144 WORCESTER STREET

NOTES FROM/SINCE LAST HEARING:

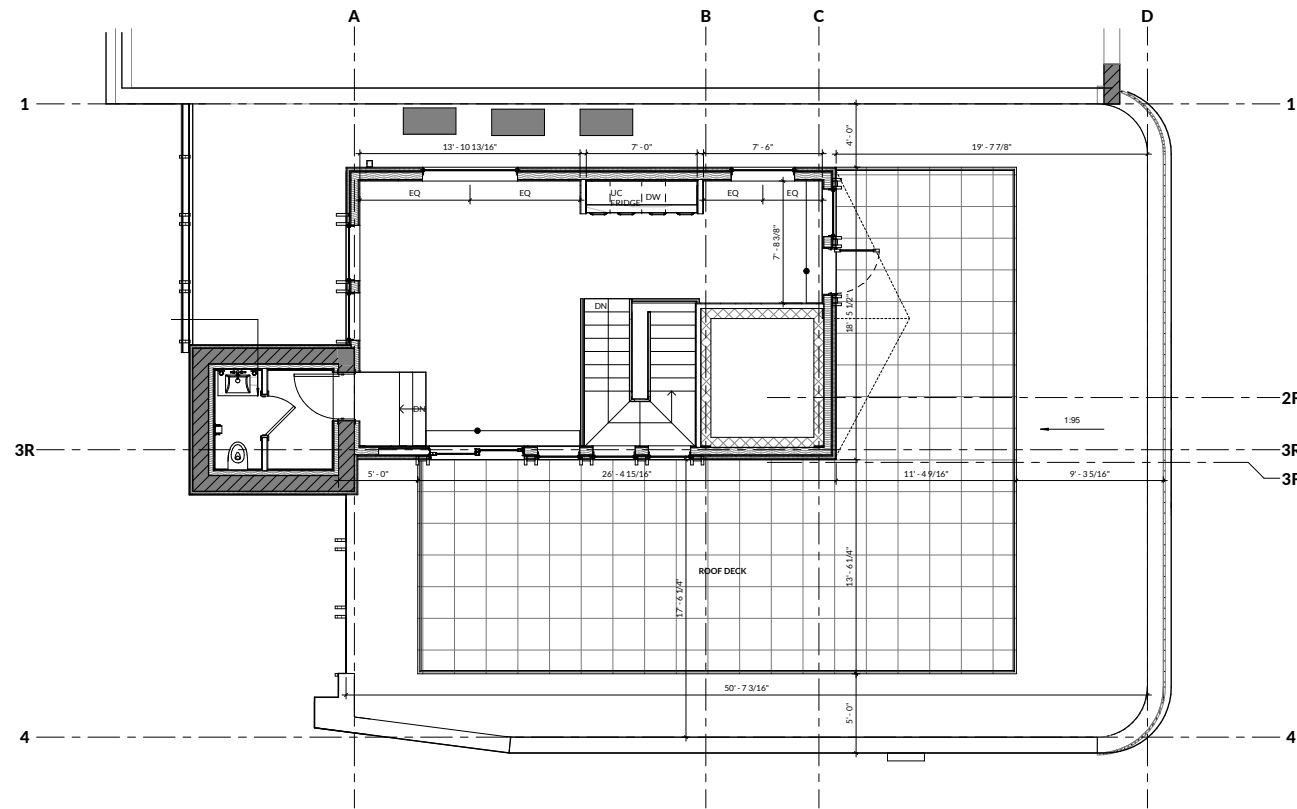
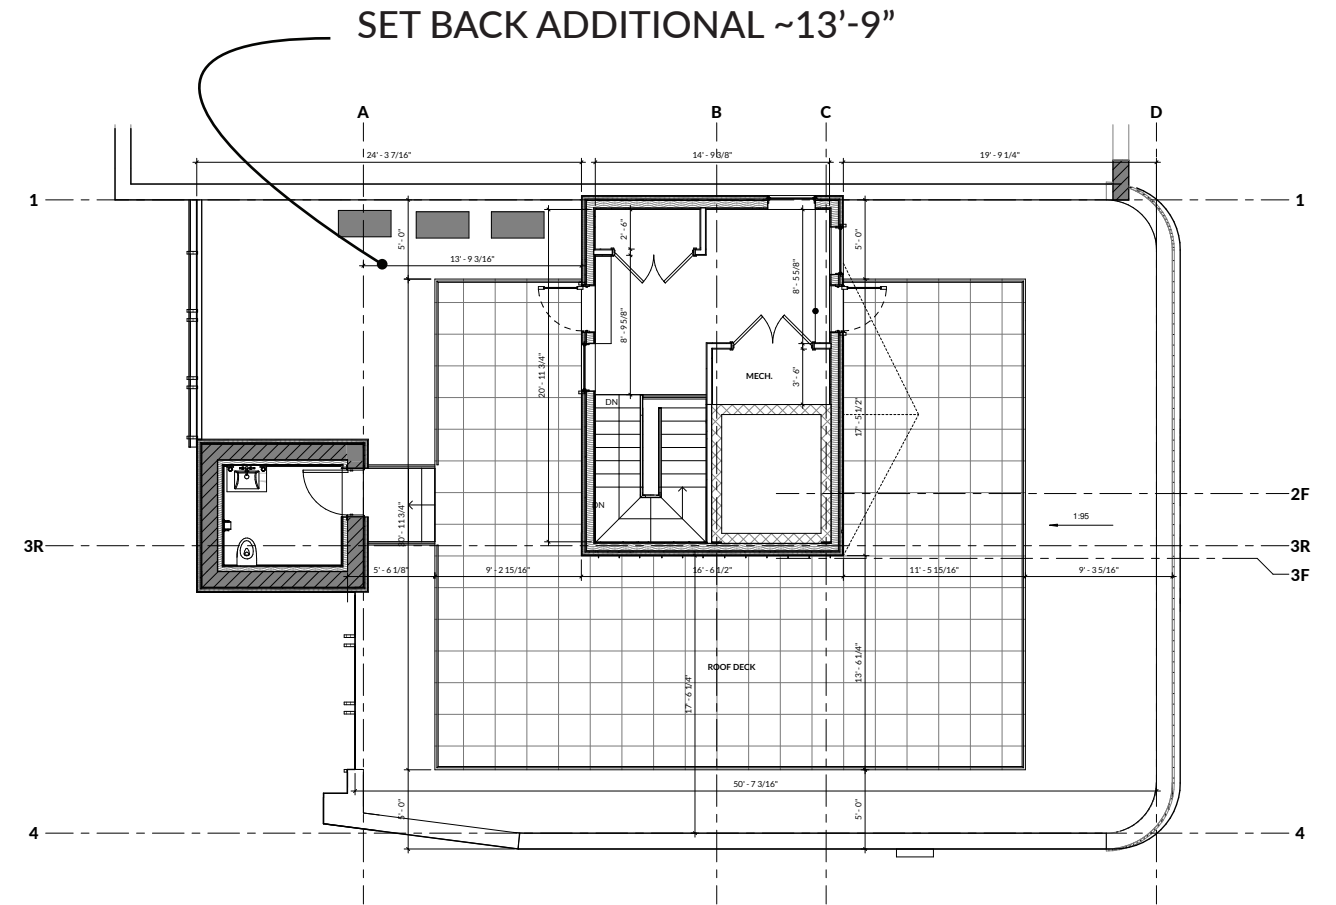
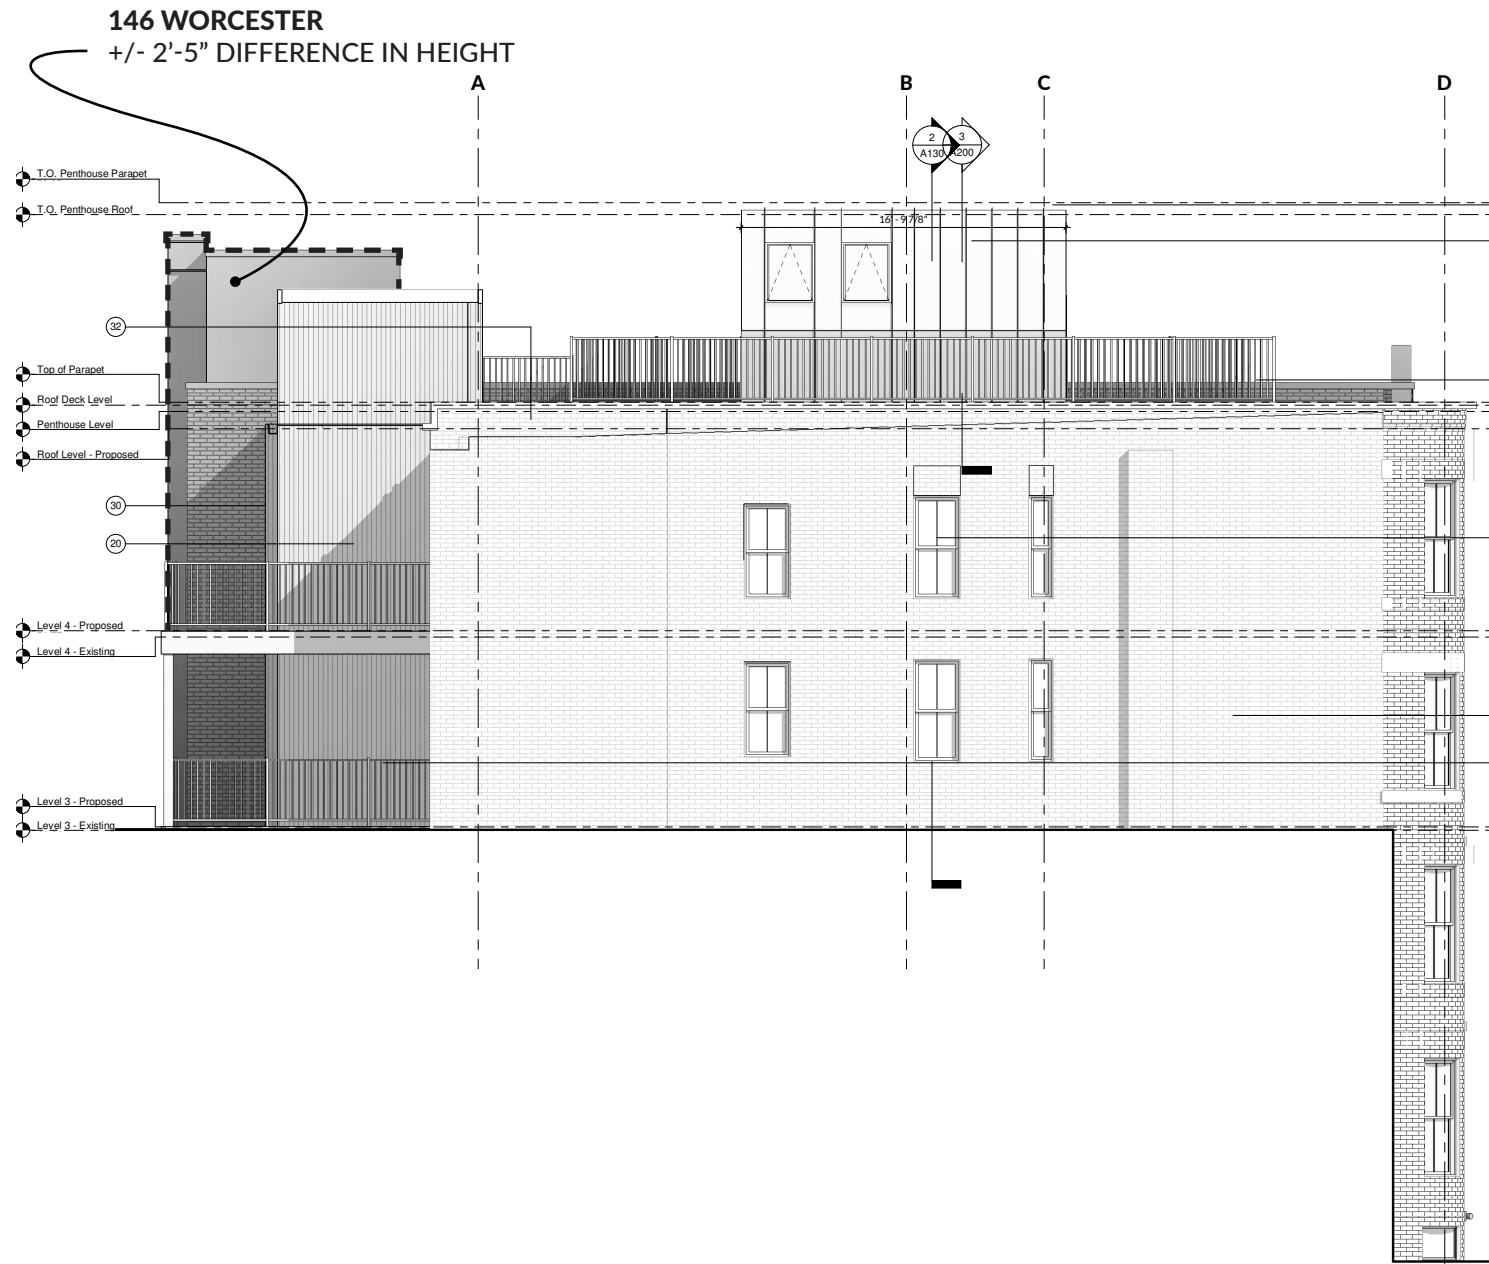
- Presented modified and smaller design for roof top addition, in response to comments from Abutters

- **COMMISSION AND ABUTTERS DISCUSSED POTENTIAL OF MASSING CHANGES TO MINIMIZE VISIBILITY OF FRONT CORNER OF ADDITION.**

PROJECT TEAM ADJUSTED MASSING, ADDING A SLOPED ROOF, AWAY FROM POTENTIAL SIGHT LINES, IN ADDITION TO SHRINKING ADDITION BY 50%.

Addition is positioned back and away from south elevation to minimize visibility.
Deck will be composite decking with black metal picket railing 3'6" off of deck.
See additional details on the following pages.

50%
REDUCTION

INFILL @
**ARCH
TRANSOMS**

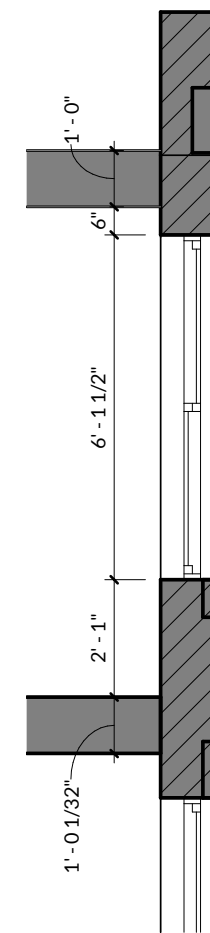
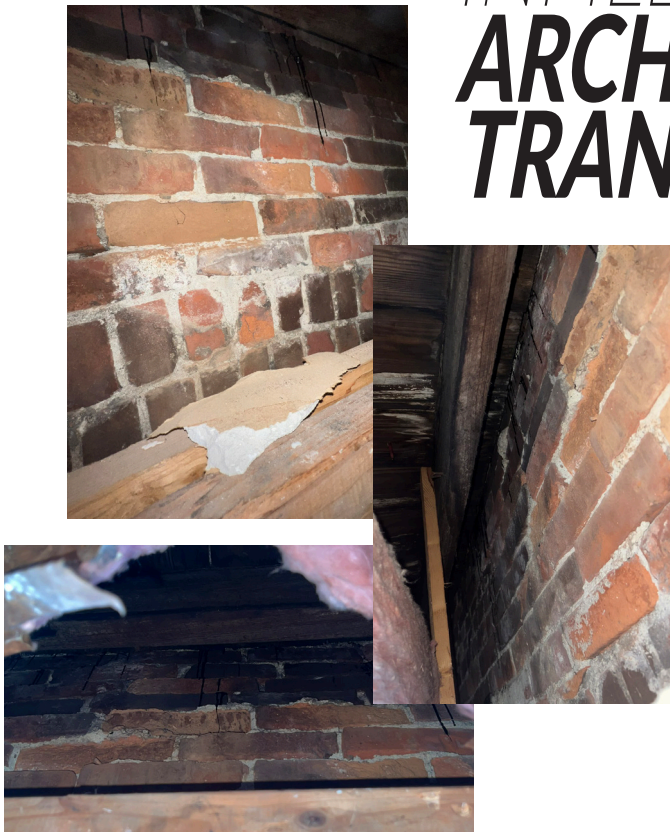
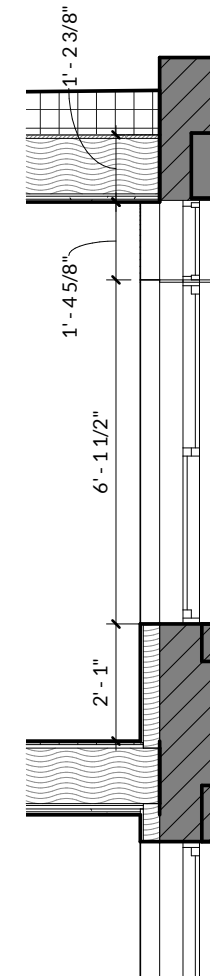
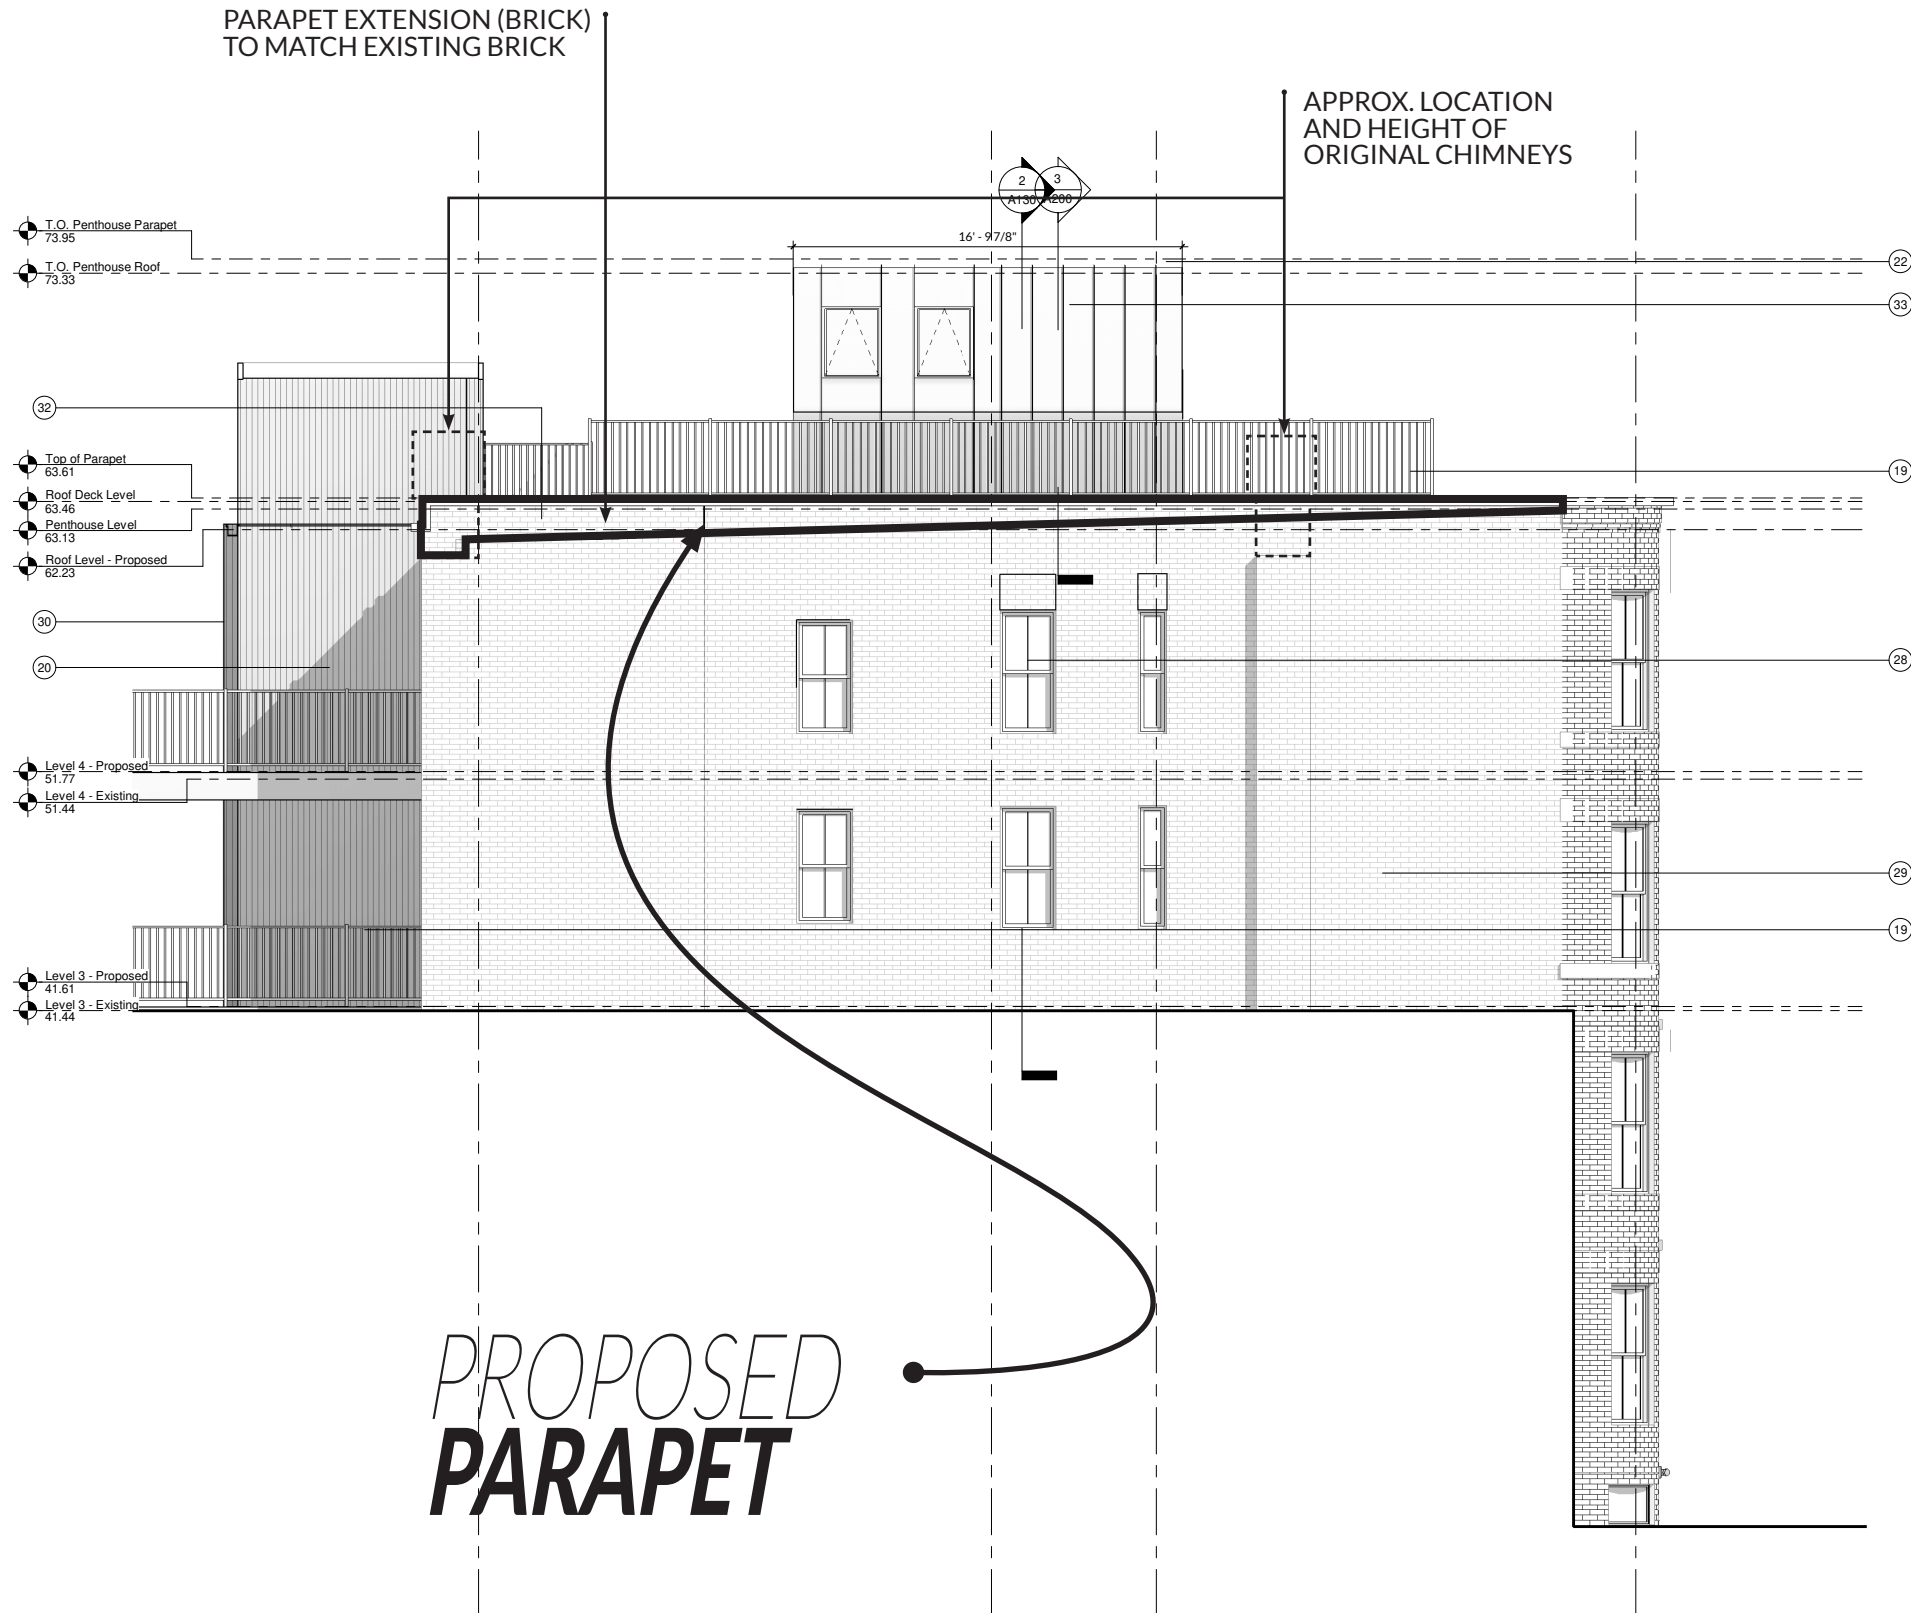
- **PROJECT TEAM DISCOVERED EVIDENCE OF BRICK INFILL AT ARCHED TRANSOMS AND PROPOSES TO RESTORE.**

- **PROJECT TEAM DISCOVERED WHAT WE UNDERSTAND TO BE EVIDENCE OF ORIGINAL '2 OVER 2' WINDOW CONFIGURATION THROUGH A PHOTOGRAPH ACQUIRED FROM THE SOUTH END HISTORICAL SOCIETY, SHOWING A MUNTIN AT ARCHED TRANSOM LOCATIONS.**

Since discovery of infill bricks at top floor arched transoms and review of historical photos, project proposes to restore said arched transoms in effort to preserve the original architecture. Current building roof framing was determined to have been lowered from original configuration and currently blocks arched transoms. To restore, project proposes to raise roof to allow for restoration of arched transoms. No parapet exists along building south side as it follows existing roof framing height. To allow for raising of roof, project proposes continuing height of front facade (east) parapet to side facade (south). Extended parapet will match existing bricks. This proposal also alleviates shrinking ceiling height at top floor as project proposed a new roof that will conform to building codes and will therefore be significantly deeper framing than existing 2x8 roof framing.

WINDOWS

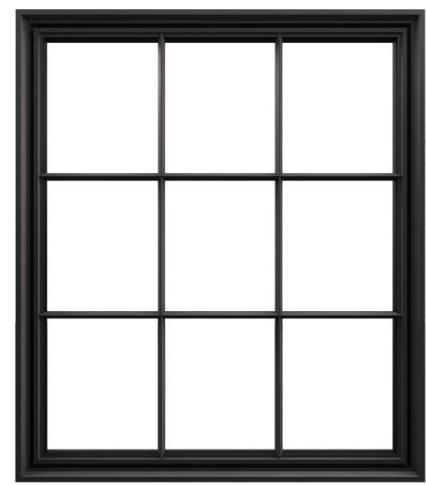
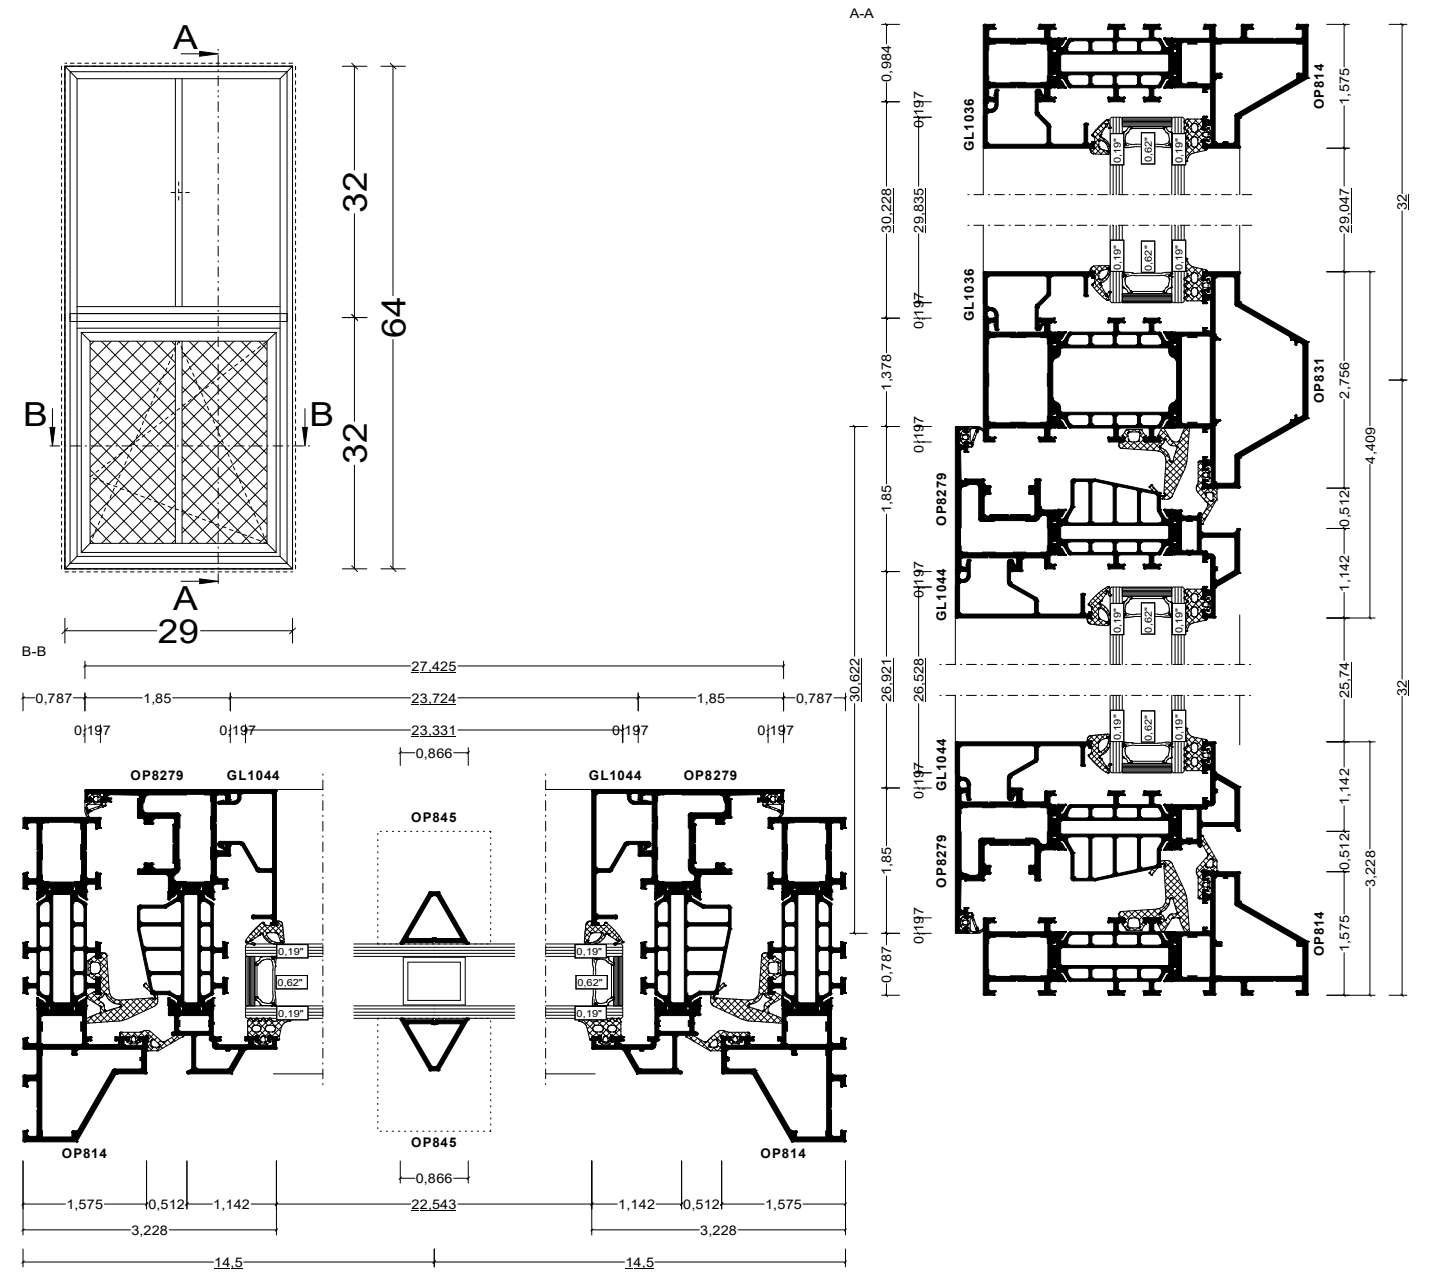
- **COMMISSION DISCUSSED USING THE PERIOD OF CONSTRUCTION TO DETERMINE THE HISTORICAL APPROPRIATENESS OF THE '2 OVER 2' WINDOW CONFIGURATION.**

CONFIRMATION WAS MADE THAT THE BUILDING WAS BUILT IN 1897 AND FALLS WITHIN THE ERA, AS DISCUSSED, THAT JUSTIFIES THE APPROPRIATENESS OF '2 OVER 2' WINDOWS.

- EXISTING ALUMINUM REPLACEMENT '1 OVER 1' WINDOWS TO BE REPLACED W/ ALUMINUM '2 OVER 2' WINDOWS THAT MEET THE STANDARDS AND CRITERIA FOR WINDOW REPLACEMENT
- EXISTING MISMATCHING STORM WINDOWS TO BE REMOVED
- EXISTING WOOD BRICKMOLD PROFILE TO BE REPLACED TO MATCH EXISTING
